STAGE 2 - PROPOSED ROAD UPGRADE

MOUNTAIN RIDGE ROAD, NEW BEITH

PLANS AND DOCUMENTS referred to in the PDA DEVELOPMENT APPROVAL

Approval no: DEV2025/1618

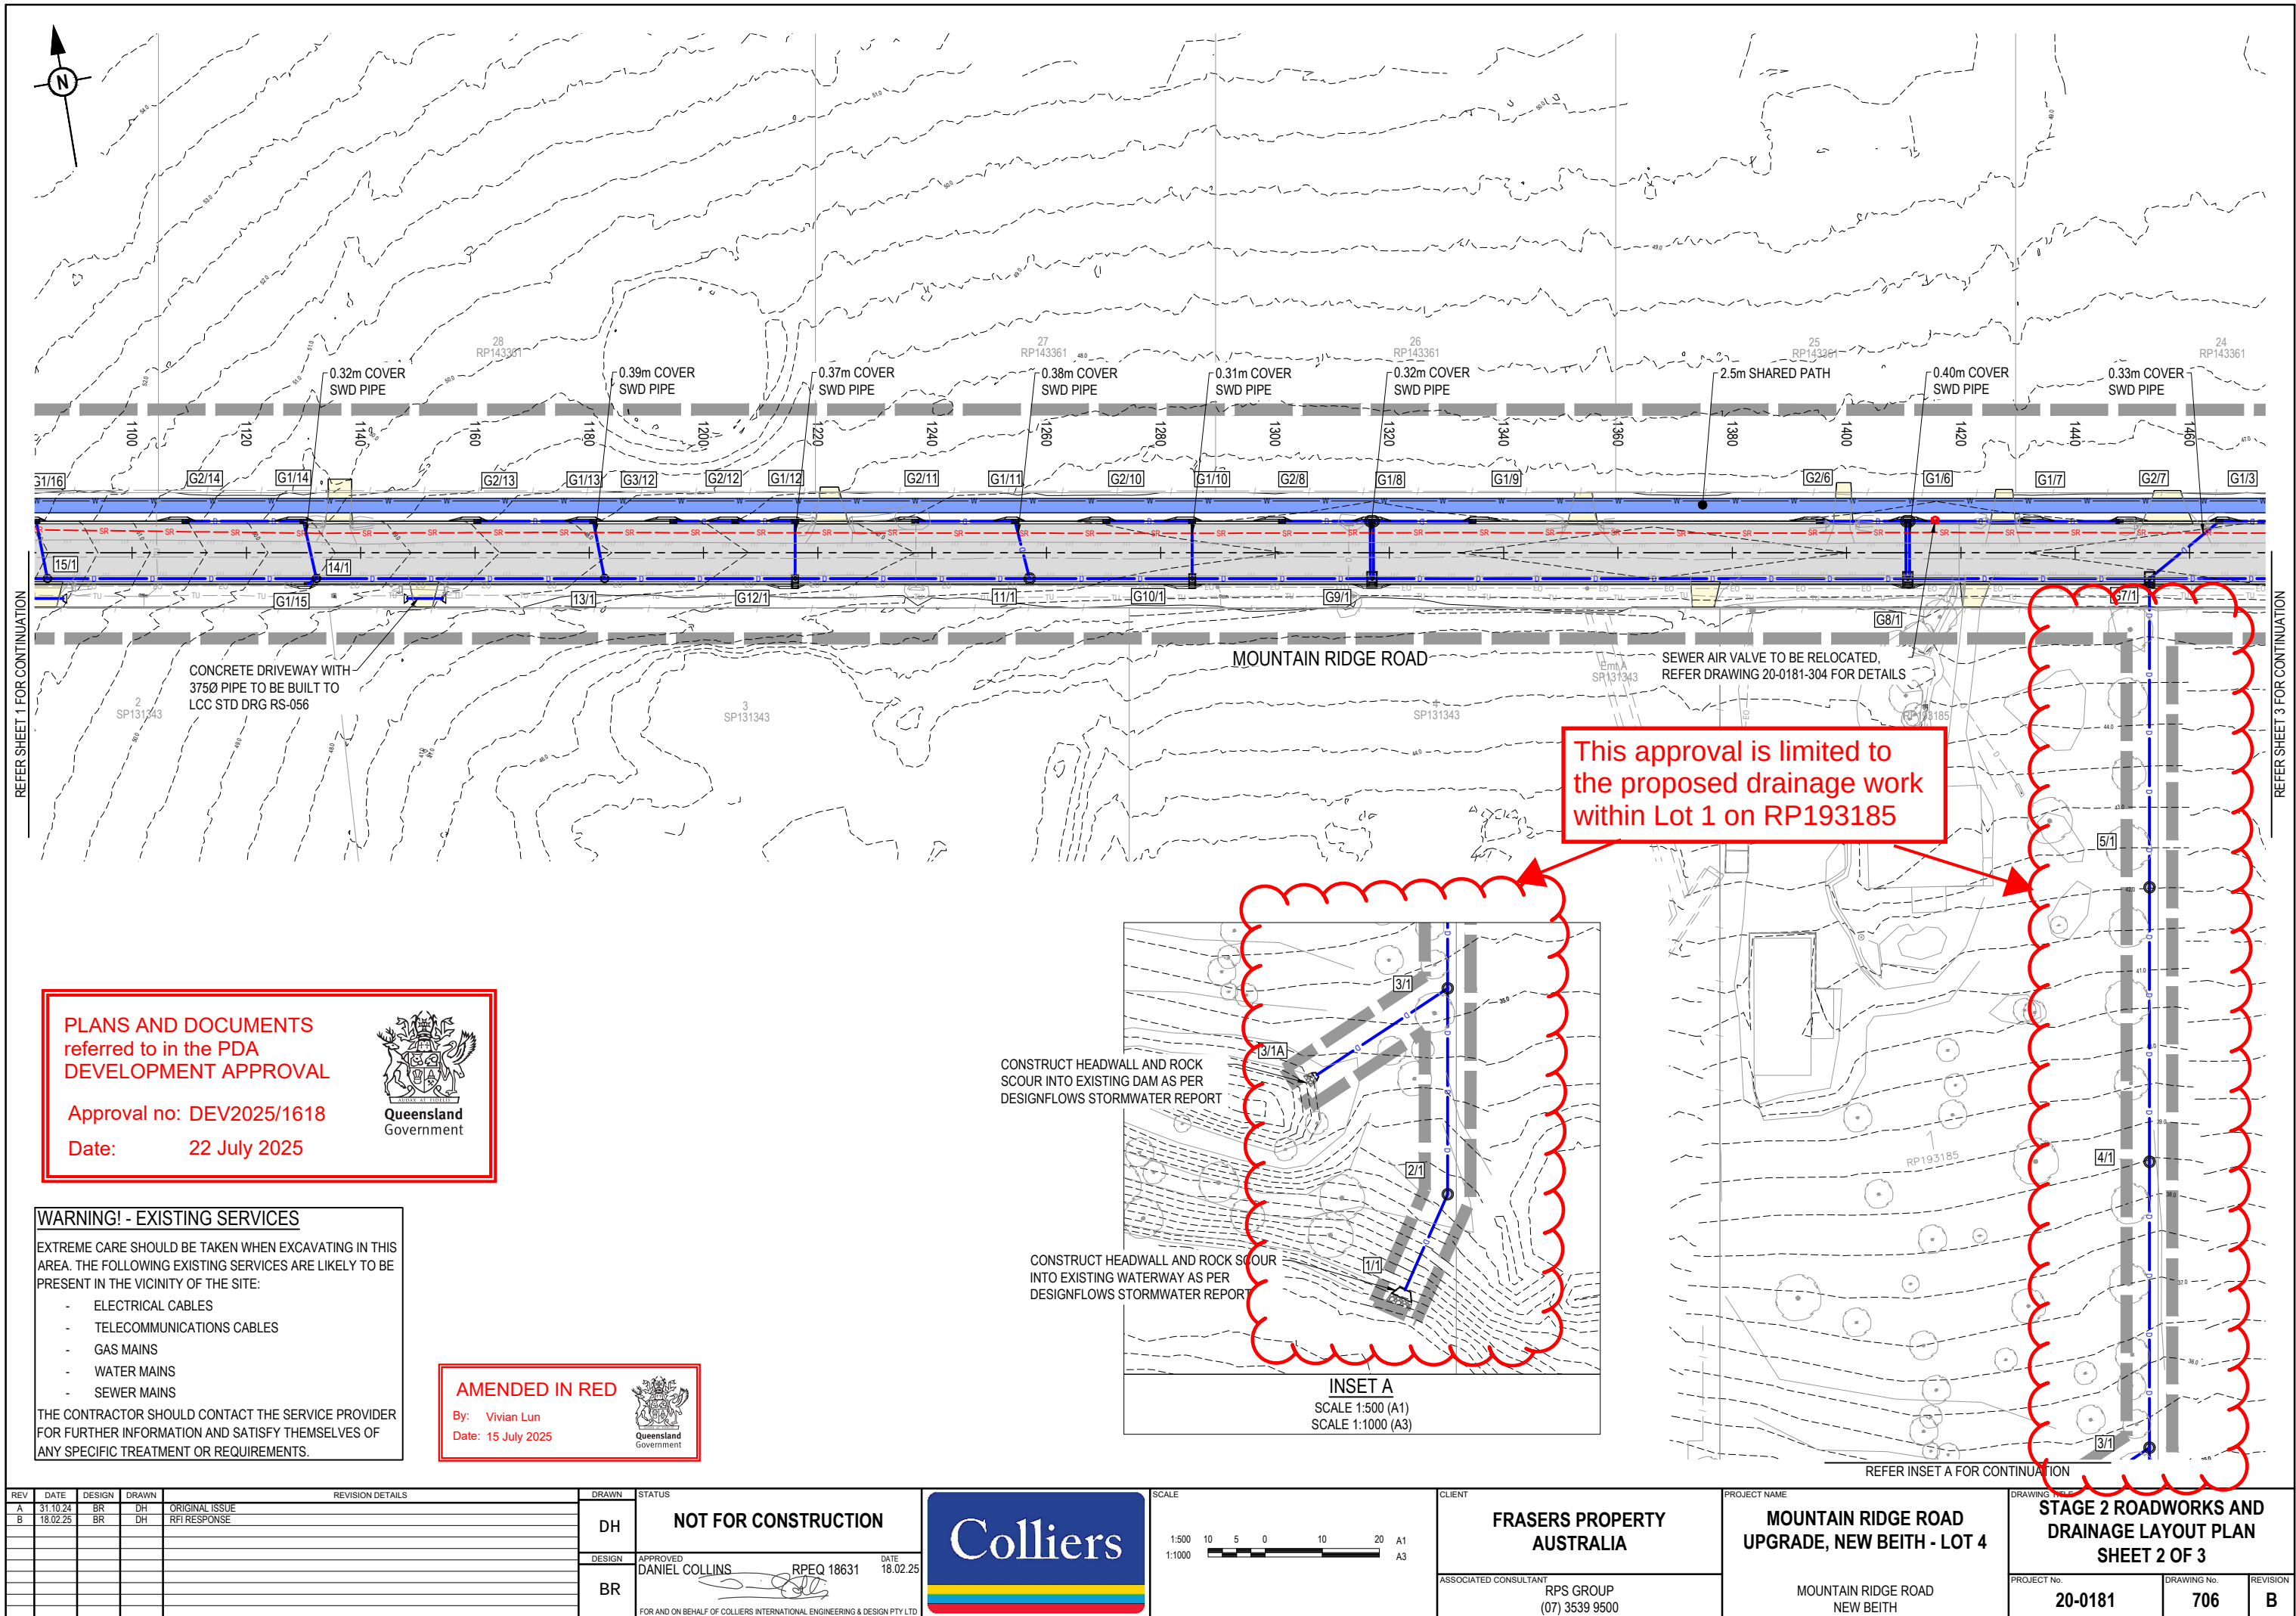
This approval is limited to the proposed drainage work within Lot 1 on RP193185

AMENDED IN RED

DRAWING TITLE
STAGE 2 STORMWATER DRAINAGE CATCHMENT LAYOUT PLAN SHEET 2 OF 3
PROJECT No.
20-0181
DRAWING No.
723
REVISION
B

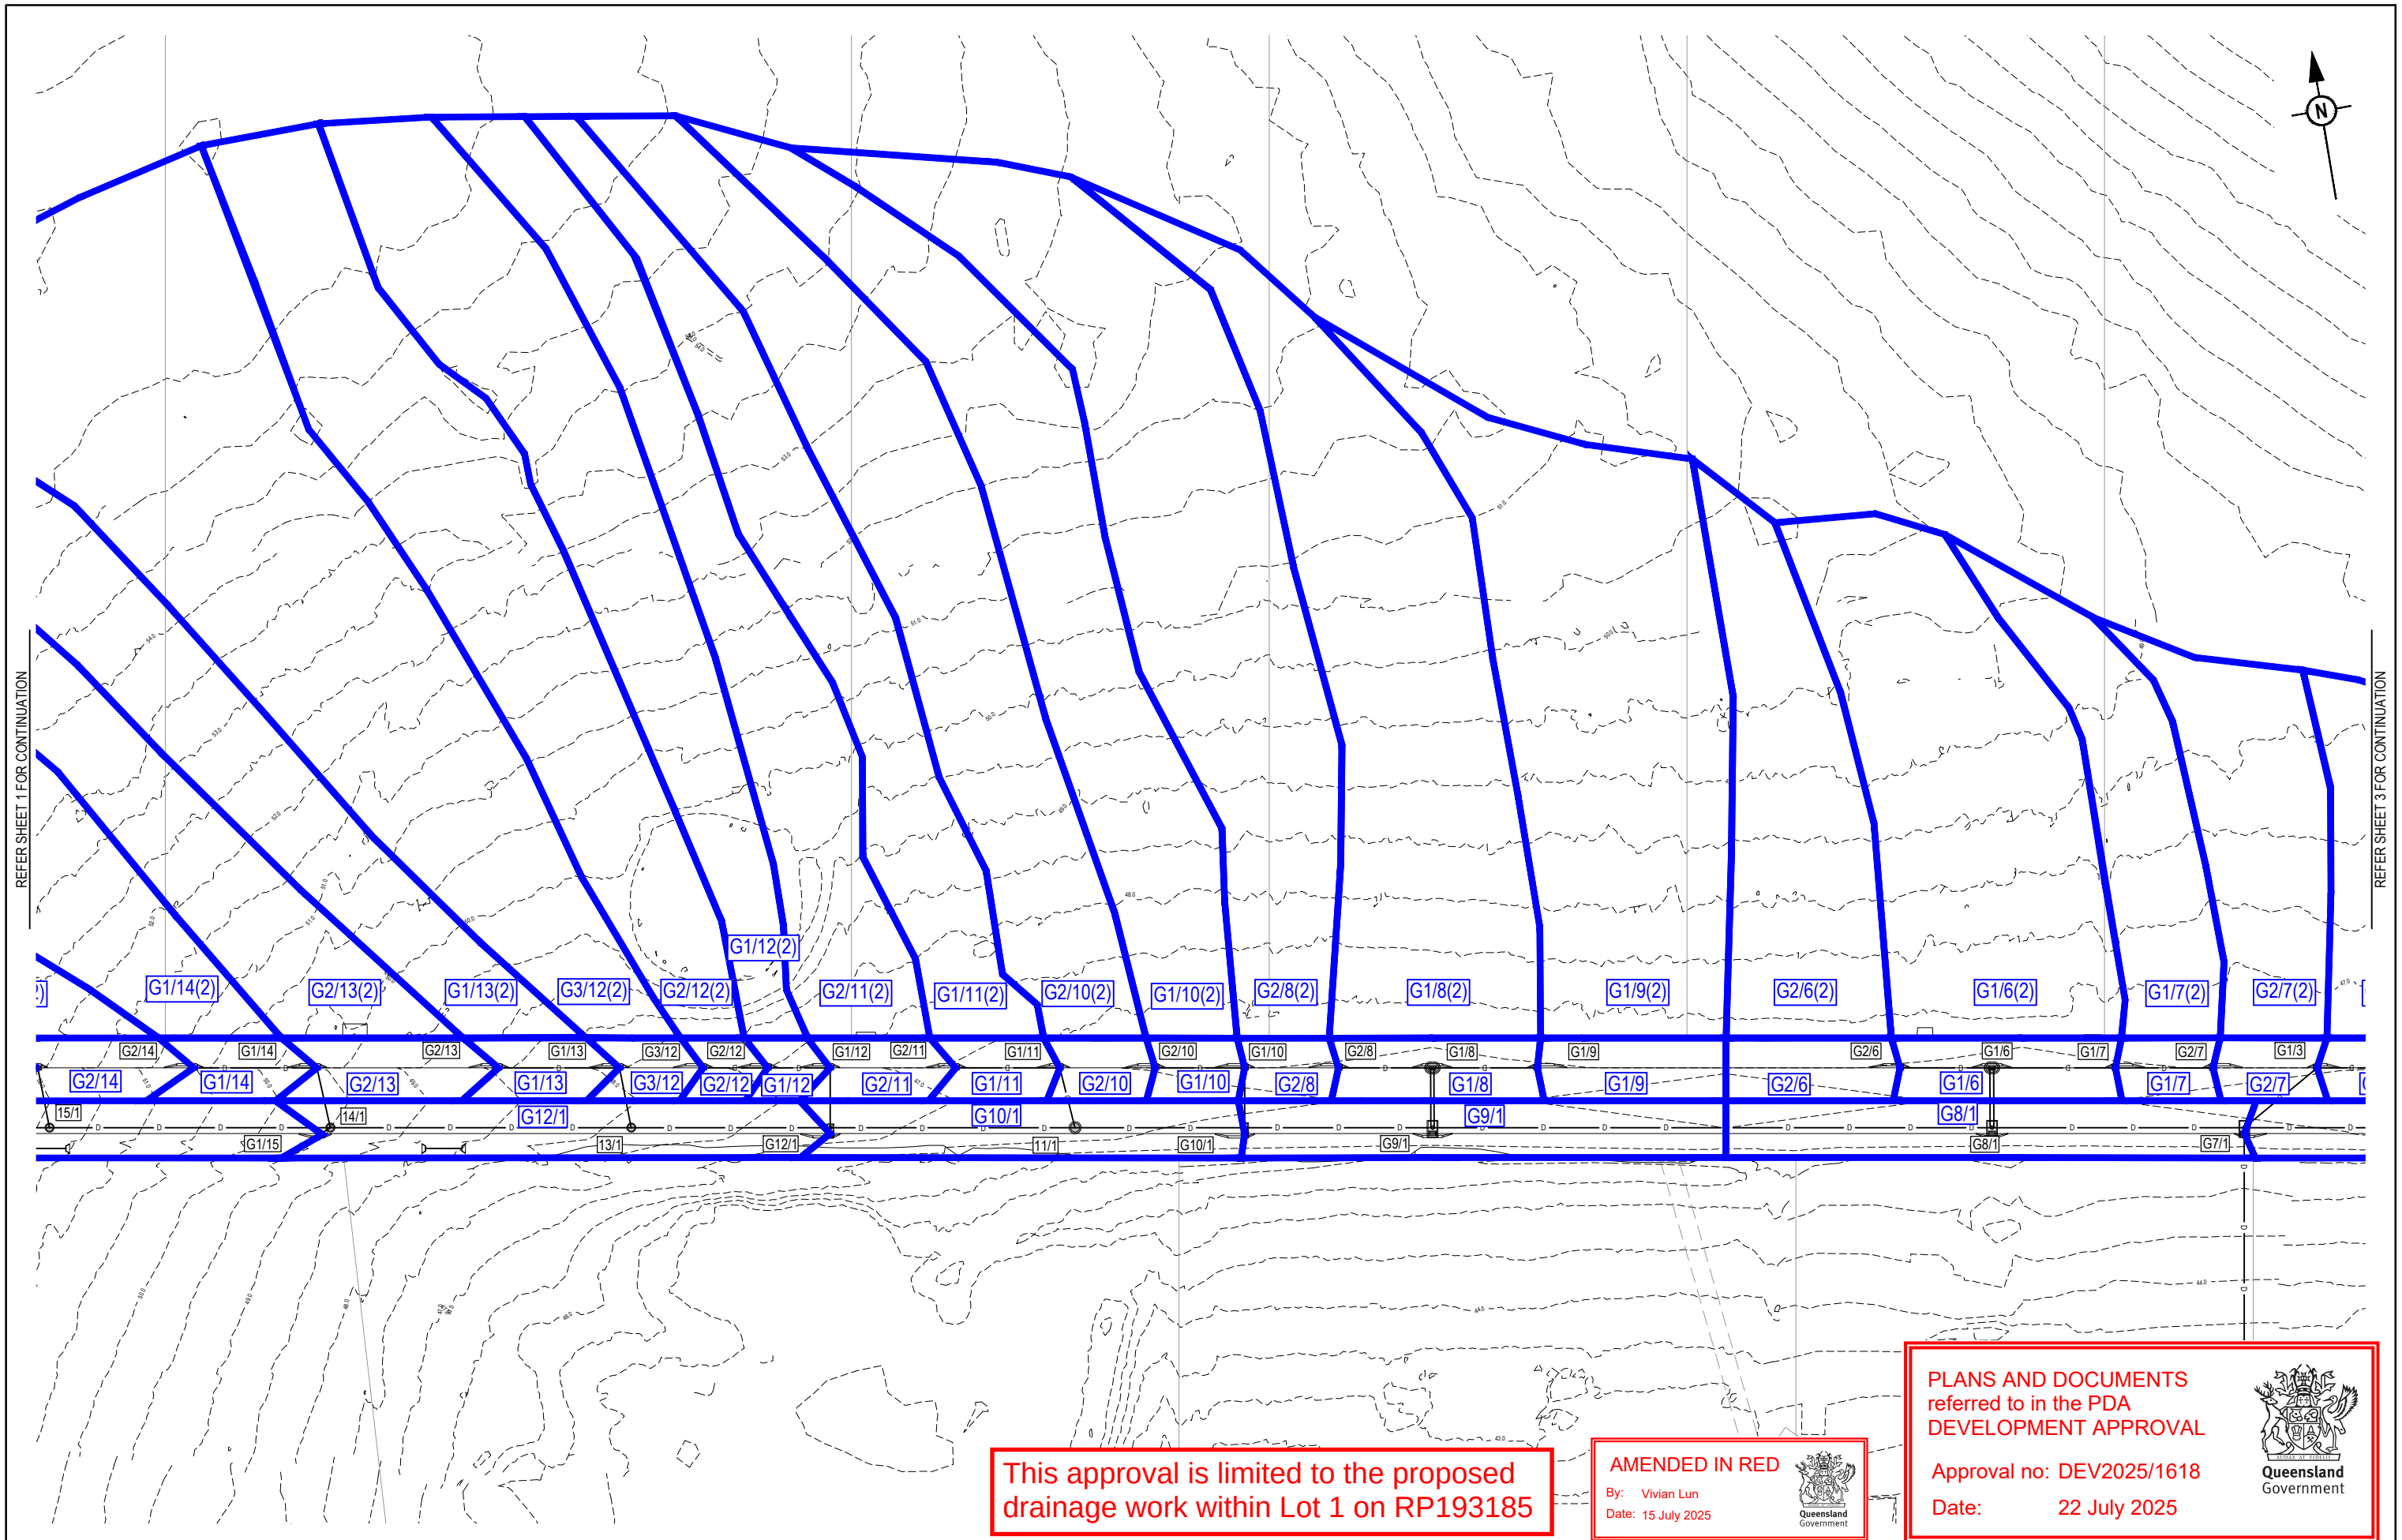
This approval is limited to the proposed
drainage work within Lot 1 on RP193185

AMENDED IN RED

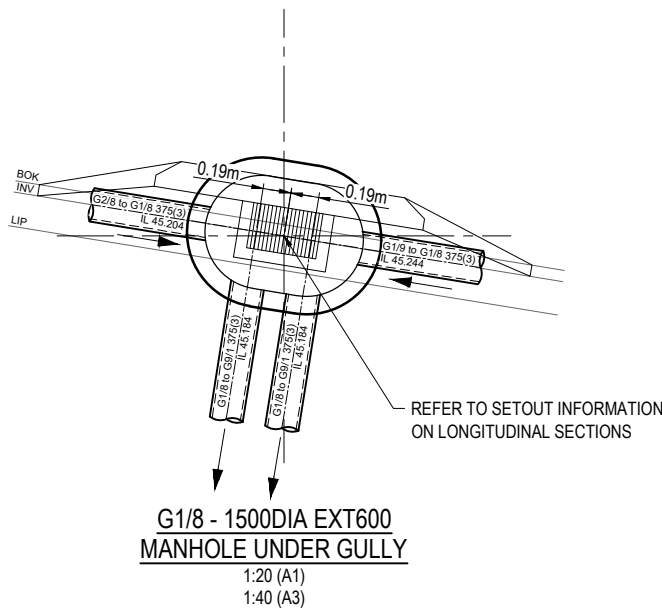
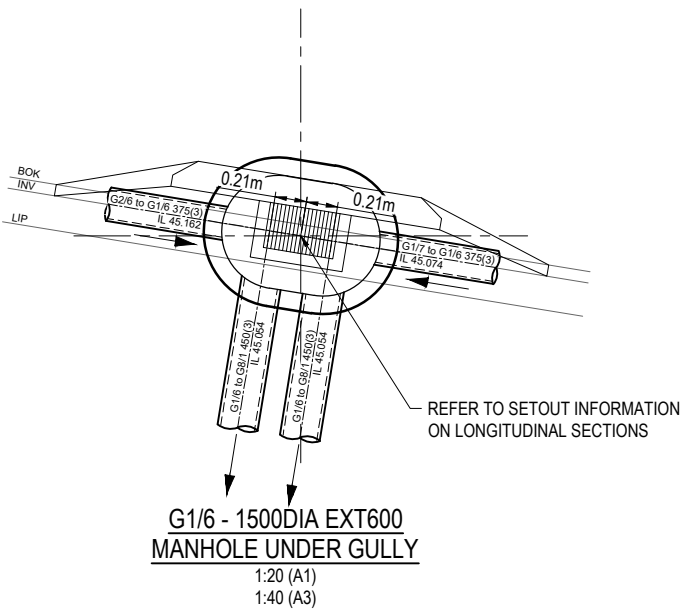
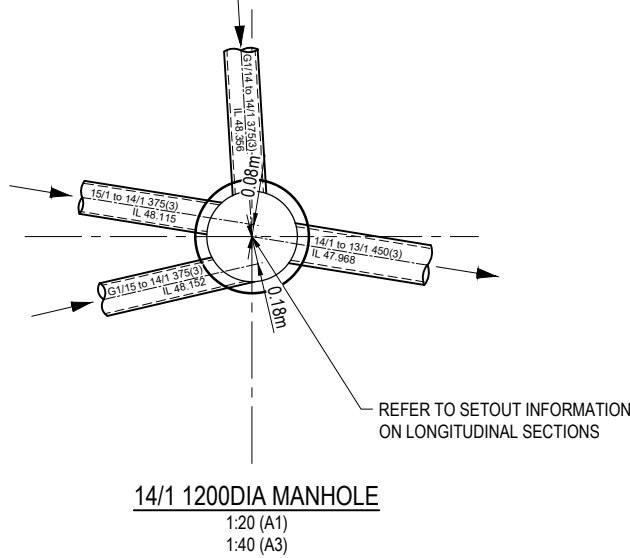
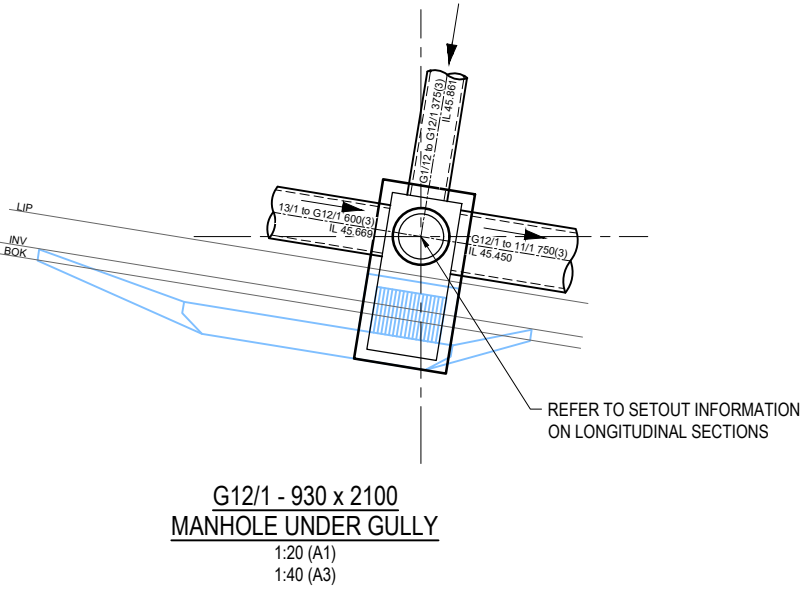
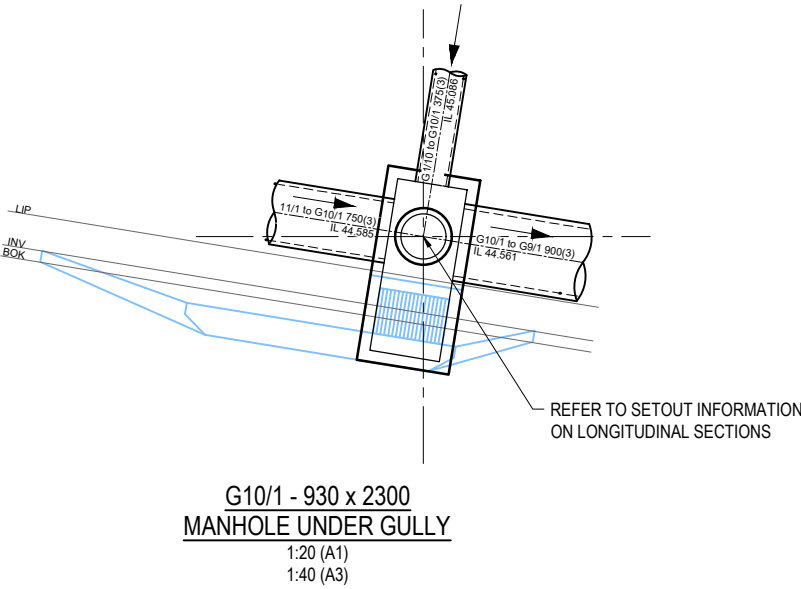
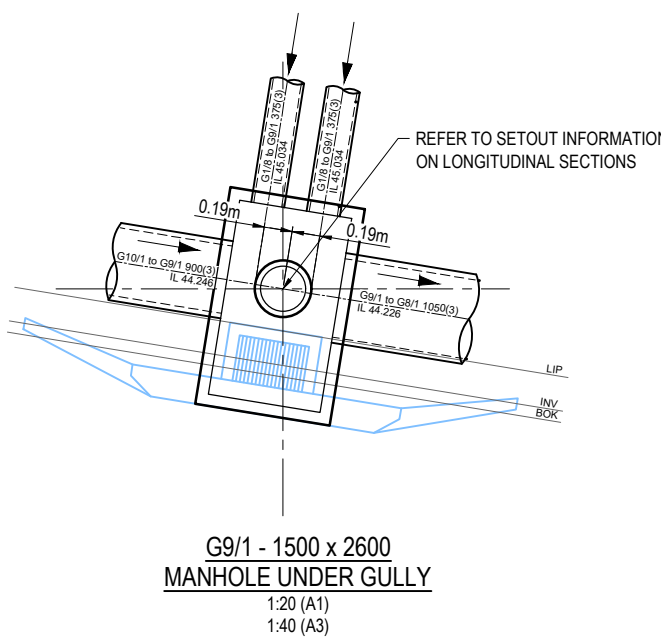
AMENDED IN RED

This approval is limited to the proposed
drainage work within Lot 1 on RP193185
